PREAMBLE AT HANNAH RIDGE
FILING NO. 3
STREET IMPROVEMENT PLANS
NIGHTWIND HEIGHTS, EQUINE CT./CUL-DE-SAC

PUBLIC EXTENDED DETENTION BASIN GRADING AND OUTLET PROFILE POND 1

V1_Construction Drawings (Plans-Profiles).pdf Markup Summary

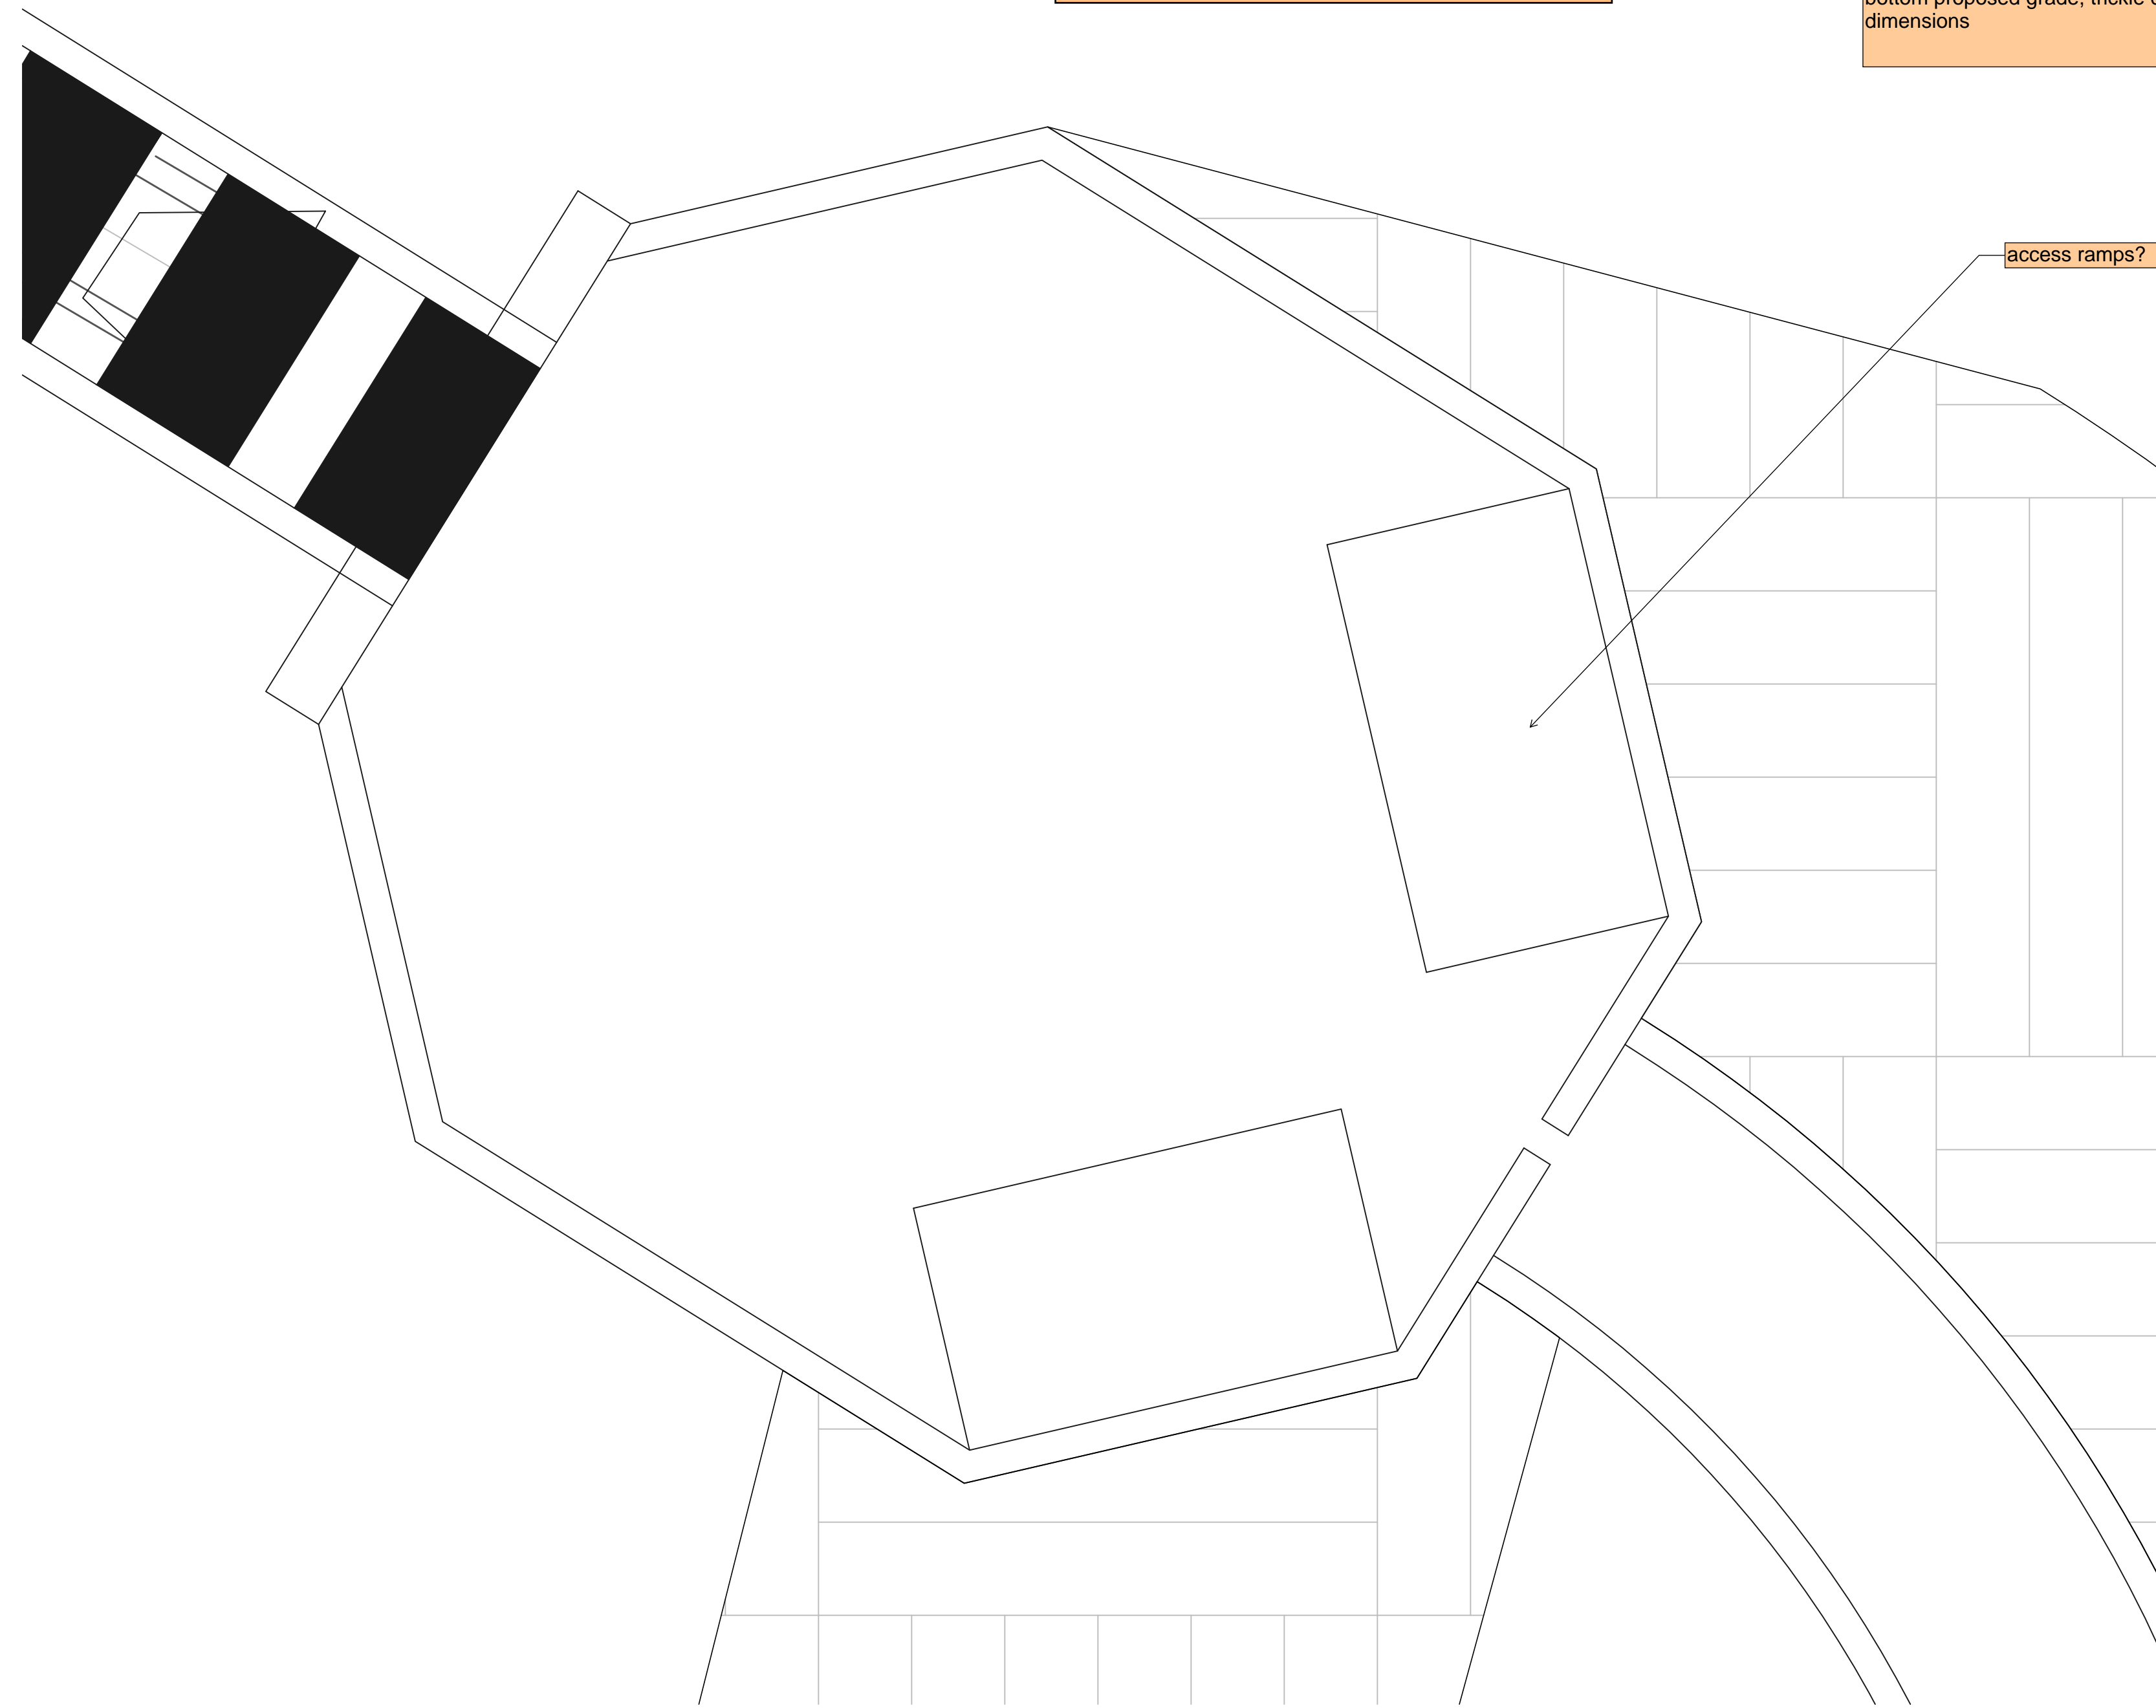
Pond bottom should have a minimum slope of 3% to the trickle channel and micropool (USDCM Vol 3, detail T-5).

Show longitudinal slope (between 0.4-1% is recommended)

Assign a name/number to all PBMPs and then update all submitted text and drawings accordingly with consistent labeling throughout (example: "Pond A" or "Pond 1").

label forebays

CONCRETE FOREBAY 'A'
SCALE: 1" = 2'

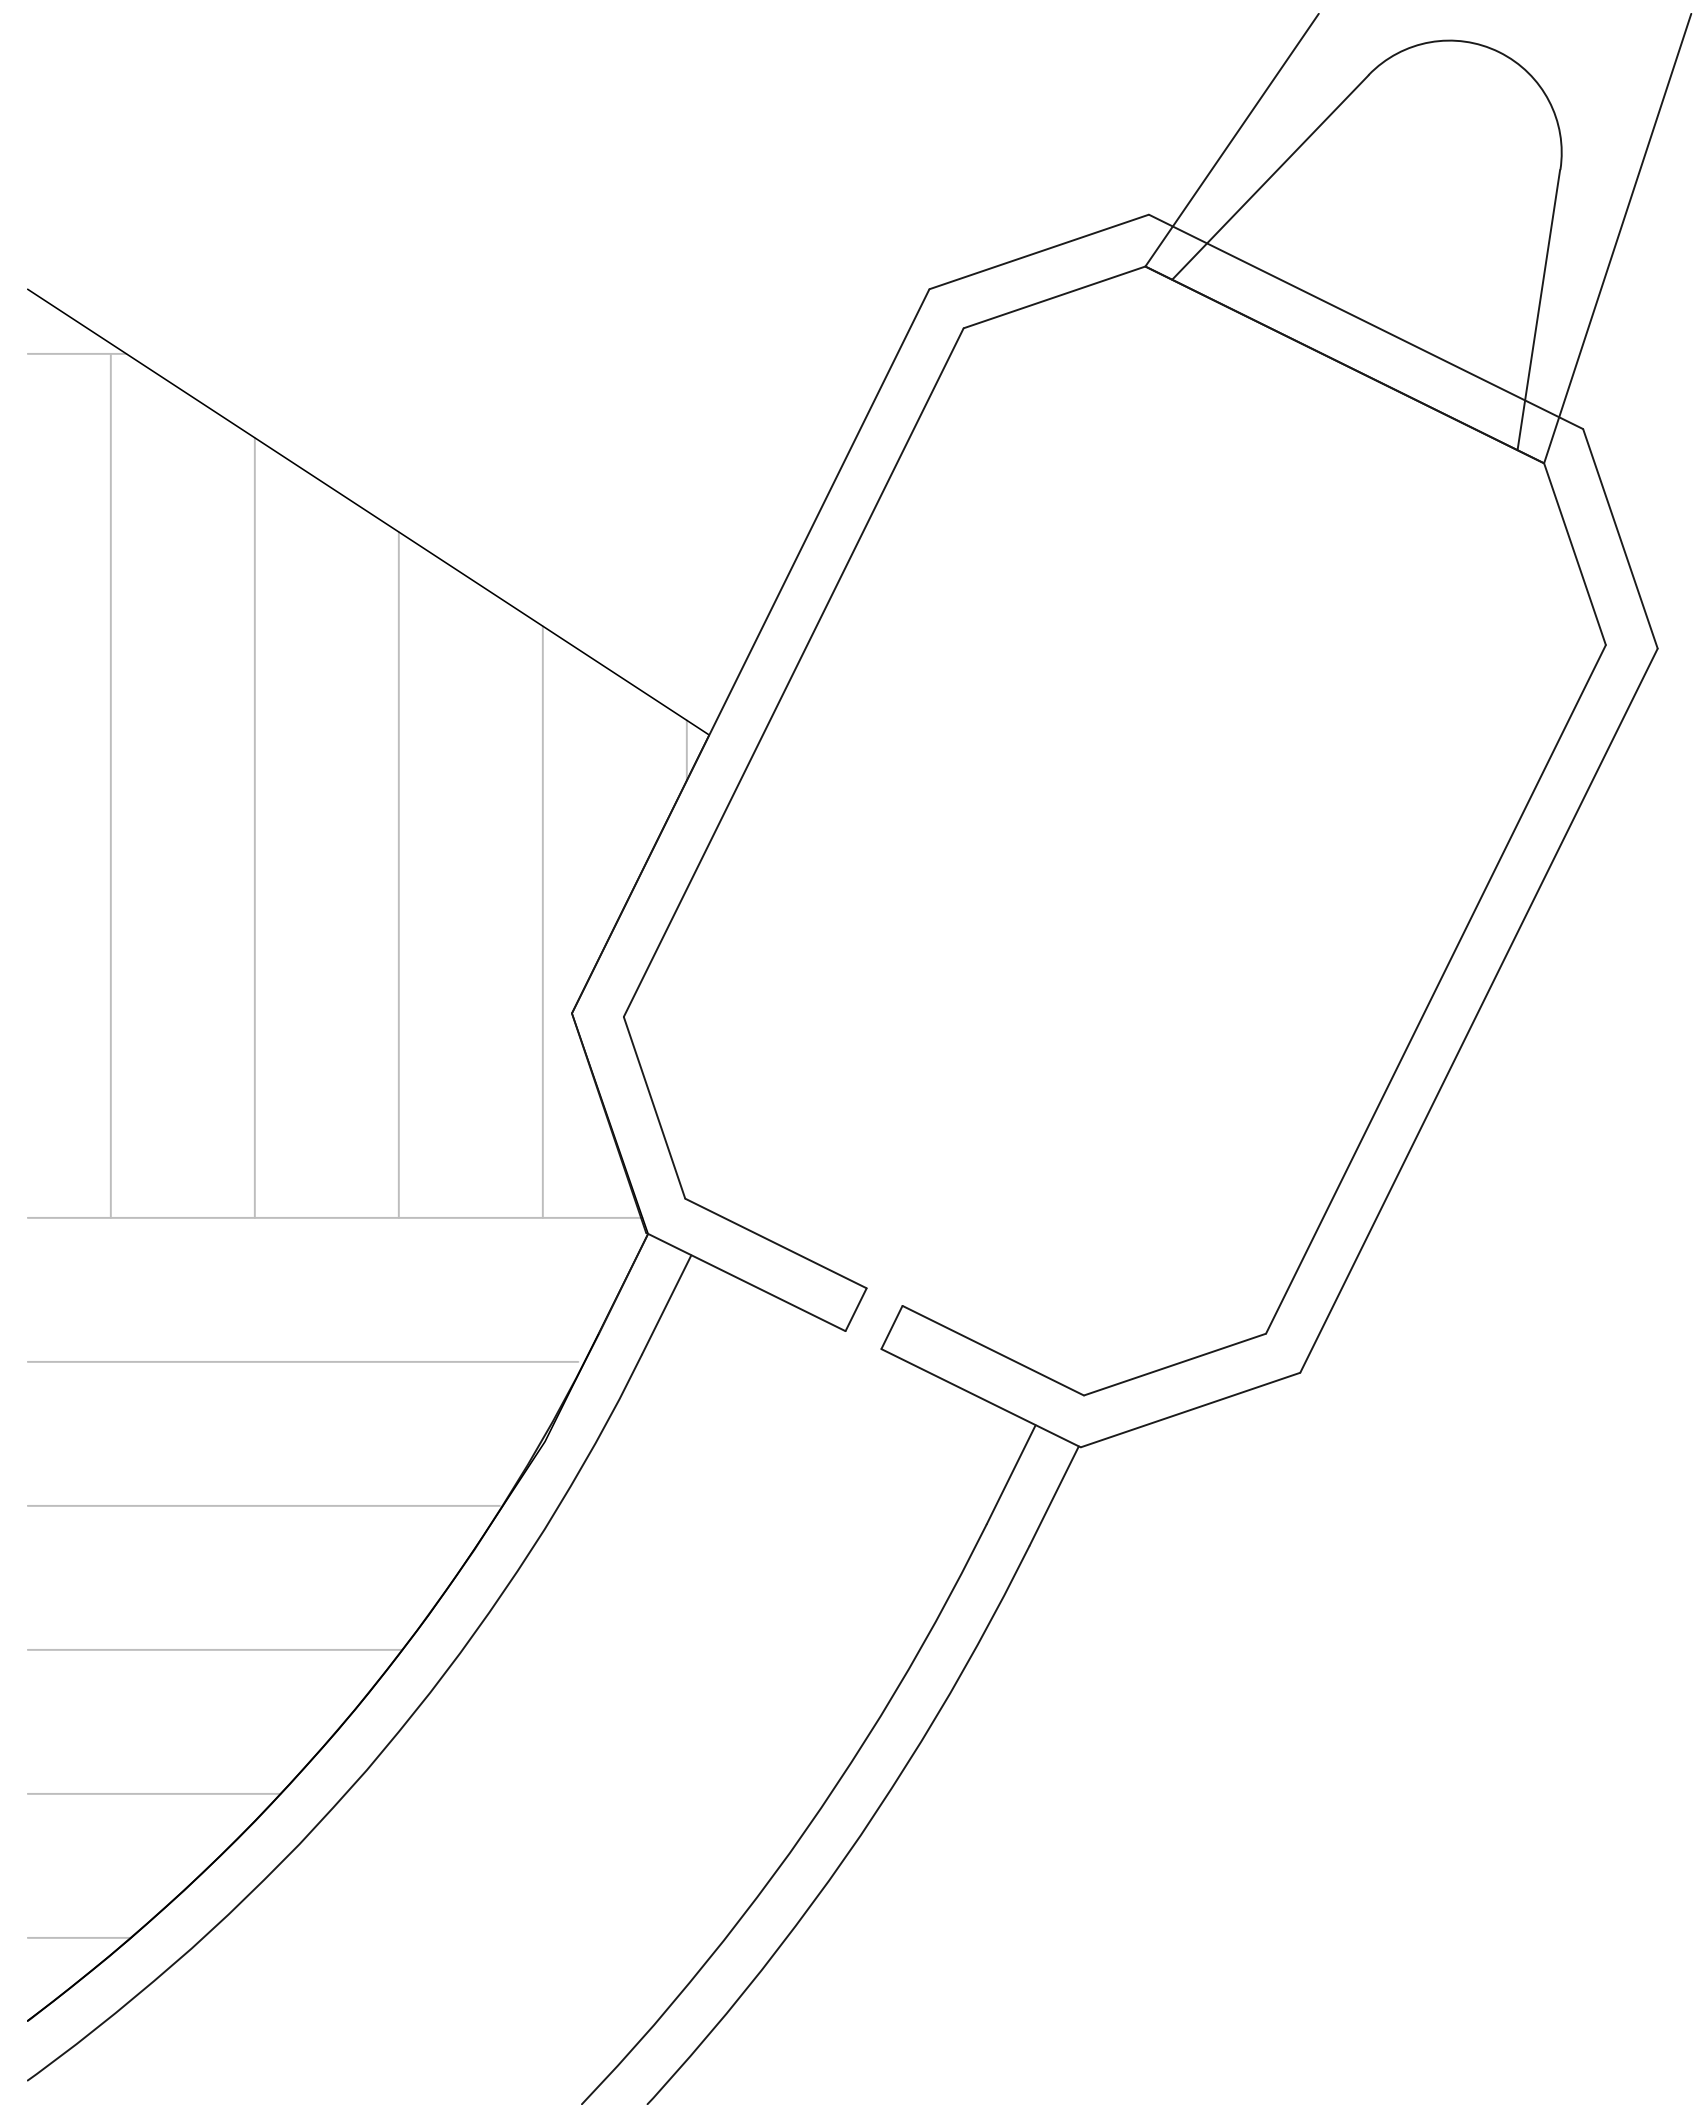
Provide dimensions of forebays

show forebay cross section with inlet pipe size and elevation, surrounding pond bottom proposed grade, trickle channel dimensions

access ramps?

CONCRETE FOREBAY "A" NOTCH
N.T.S

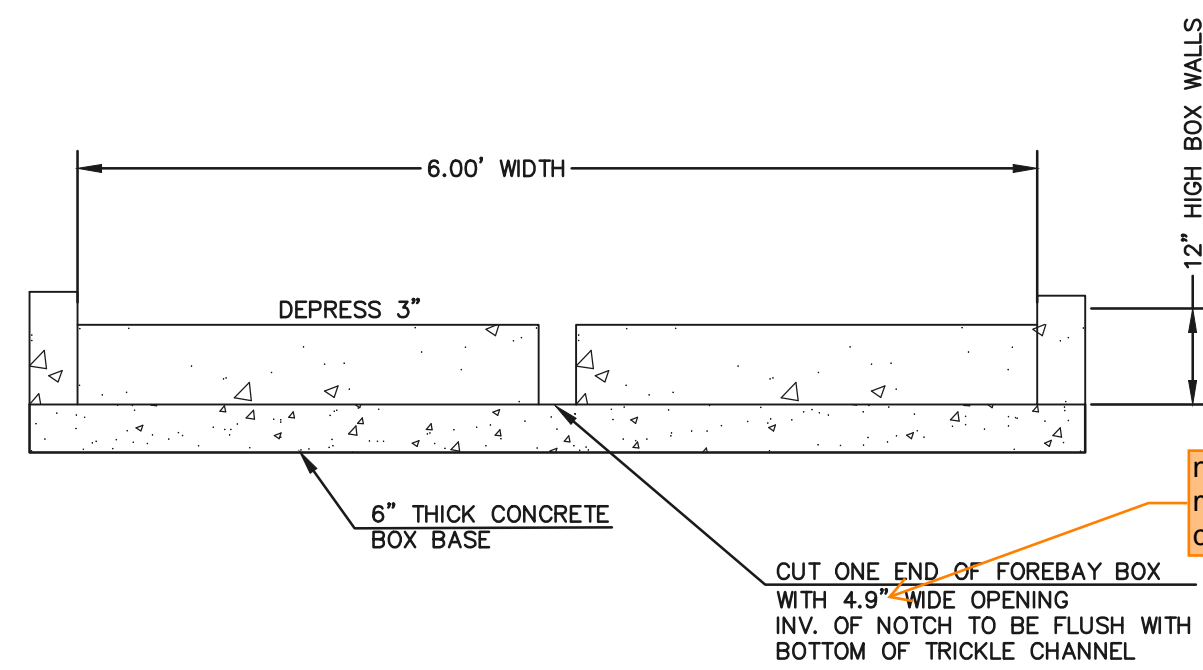
notch width does not match either forebay's calcs page in FDR

CONCRETE FOREBAY "B" NOTCH
N.T.S

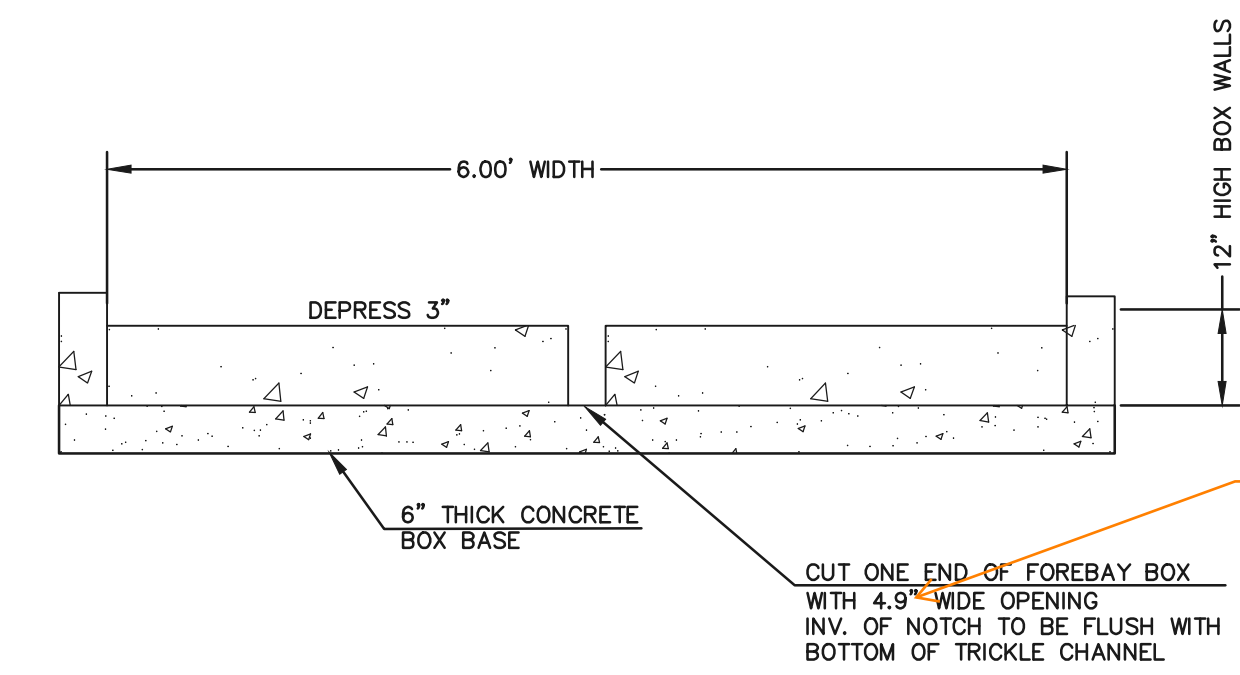
notch width does not match either forebay's calcs page in FDR

4'x4' OUTLET BOX ORIFICE PLATE
SCALE 1" = 2"

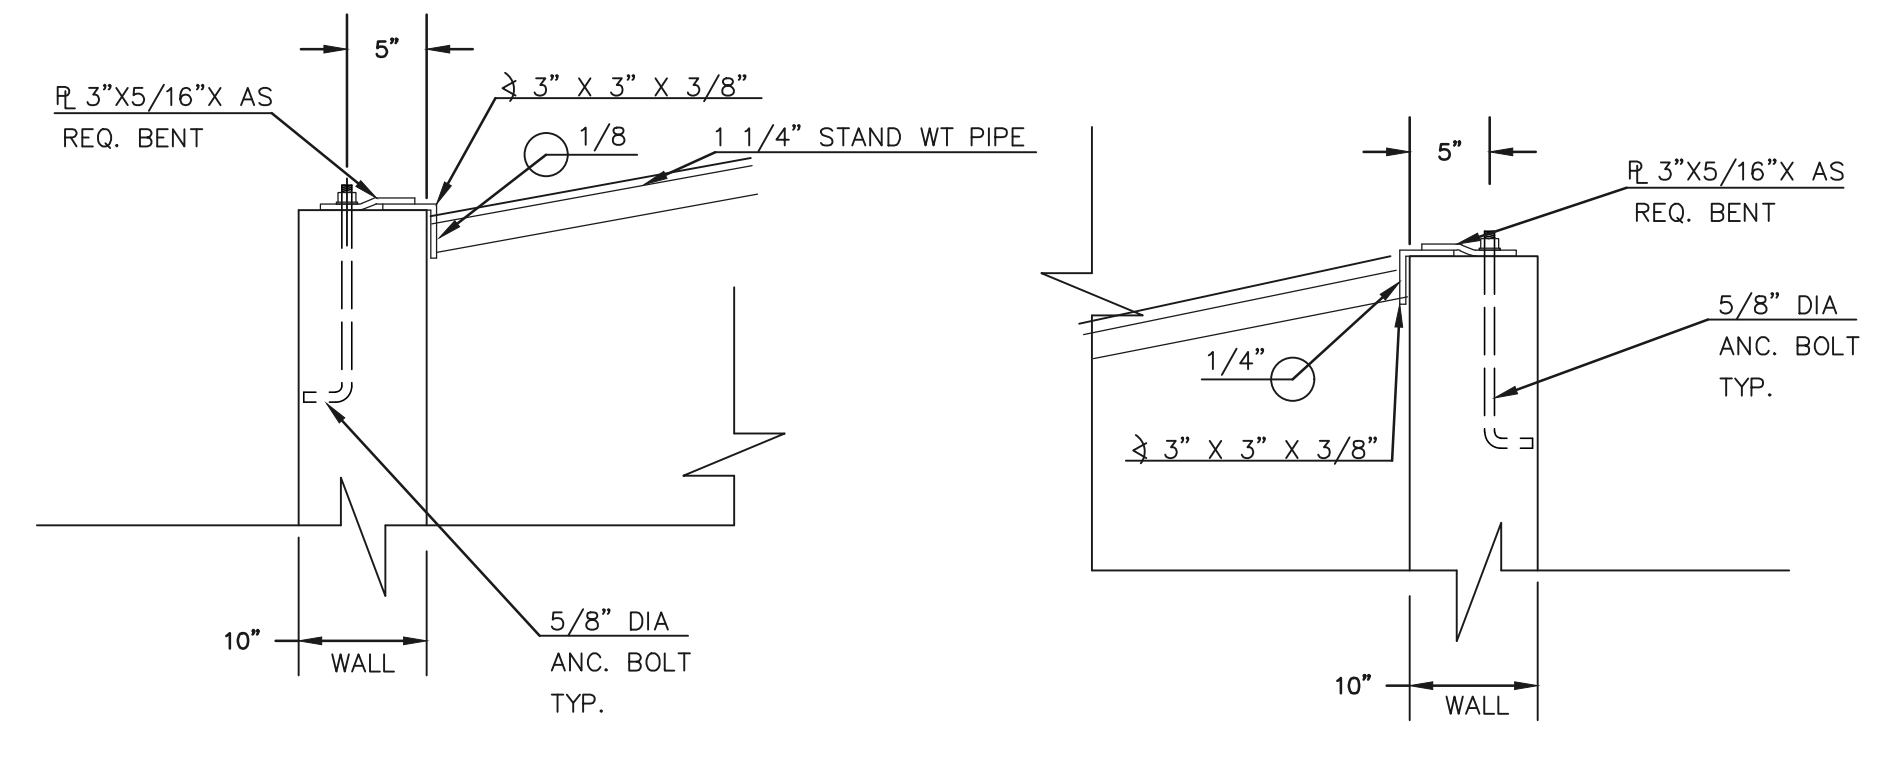
MHFD-Det Calcs only show 3 holes, each with 1.67" diameters. So quantity and diameter do not match. Revise to remove discrepancy.

clarify that this is at the centroid of the lowest orifice.
